Comment Set G0014, cont.
California Botanical Habitat

G0014-26 cont.

V. Review (re: Sunrise Powerlink A.06-08-010 and the Southern Route Alternatives)

Northern and Highest Impact Southern Overhead AC Power Line Routes

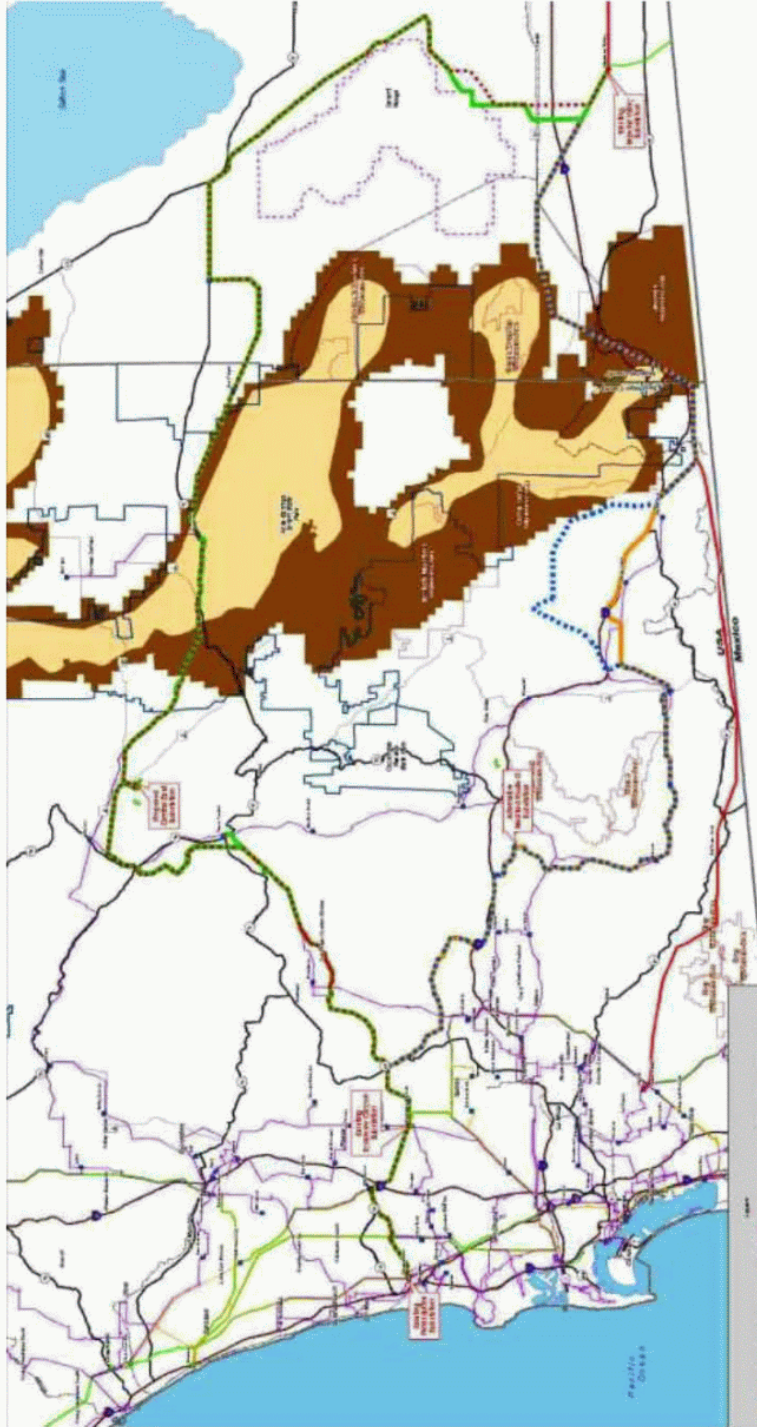
SDG&E's data shows that 1,000 megawatts would be immediately inadequate to deliver 7,000 megawatts of renewable power to San Diego, Los Angeles or Orange County. Unfortunately the cable cross sections required to deliver such capacities would be far too heavy for the pylons proposed and the cables being suspended, so many more such power lines would have to be developed. Besides as oil prices rise significantly, a dependency on plug-in hybrid vehicles would require more than 20 such 1,000 megawatt power lines for San Diego alone, and over 85 such power lines for Southern California. Overhead power line technology can not address the growing energy demands nor the engineering problems being created in California, and it would cost far more to continue with overhead AC than the considerably higher capacity underground DC systems being installed in Europe and Australia, which inflict practically no damages to the environment or any communities. The other decentralized alternative, printed solar panels, can also deliver the enormous capacity required to ultimately power the region's transportation system, at \$1 per watt, or about ½ cent per kilowatt hour.

So how could SDG&E or the CPUC object to a lower cost underground DC transmission, that can deliver 3,000 megawatts on 2 six-inch cables in one trench 1 foot wide by 5 feet deep, that can eliminate massive damages and be continuously and rapidly installed? SDG&E's data regarding transmission capacity now required (7000 megawatts) and the cost of environmental damages are not supported by their own design, while higher capacity solutions, that are far safer and have no significant environmental impact, and cost far less to install, have all been rejected. Unfortunately only the damaging alternatives are now being evaluated, with the most damaging, being the Southern Route (either Aspen's Southern Route or SDGE's Modified Southern Route). Clearly the massive damages proposed may well be disregarded because the CPUC, Aspen and SDG&E have avoided calculating the damages and avoided evaluating the losses. No total has been provided for environmental losses, geologic damages, habitat restoration costs, property devaluations, equivalent property replacement costs, medical and personal losses resulting from cancer and related health hazards due to EMF and downwind pollutant ionization exposures, the viewshed losses, a proportional loss to California's \$90 billion per year tourism and recreation industry, nor losses to ranches, businesses or to development.

Southern Route: Maximum Damages and Higher Costs

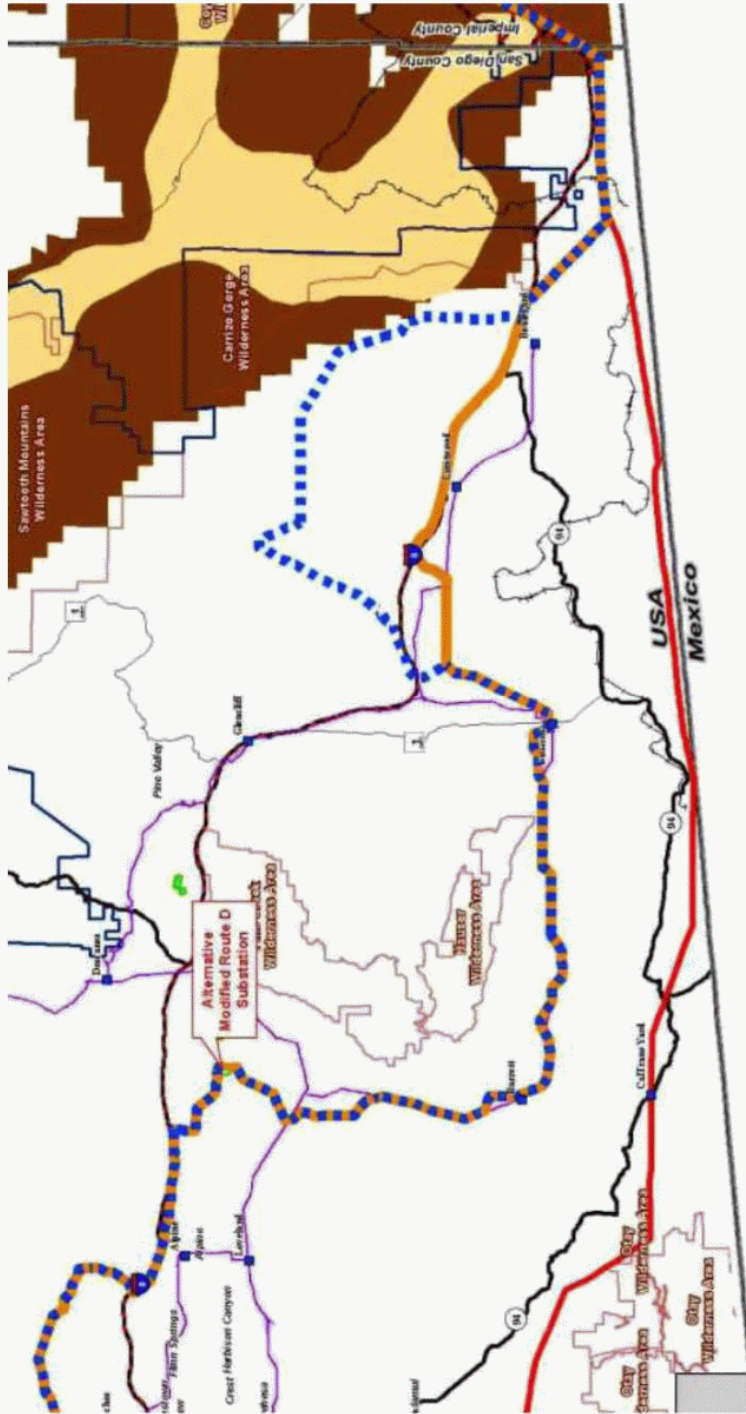
Southeast San Diego County, Asper's Southern Route (orange line), SDG&E's Route (blue dashes)

Northern vs. southern route evaluation

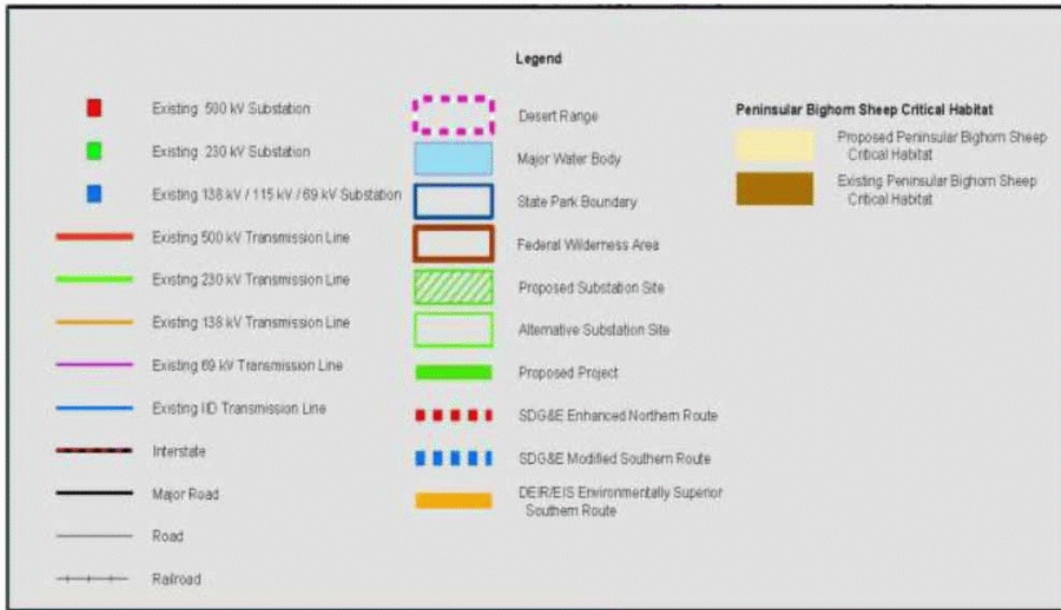
The choices for power line routes have in several significant instances been decided based on incomplete and inaccurate data, which has resulted in several erroneous conclusions, all without considering the significantly less damaging alternatives which are available and without evaluating the cost of the damages being inflicted. That offers the possibility of a needless, massive and a very costly disaster. The alternatives available for the Southern Route, including underground DC and the cost of the alternative approaches to installation, as well as the environmental and economic damages have not been evaluated for the Sunrise Powerlink, nor have the most significant alternatives been considered, particularly for the Southern Route.
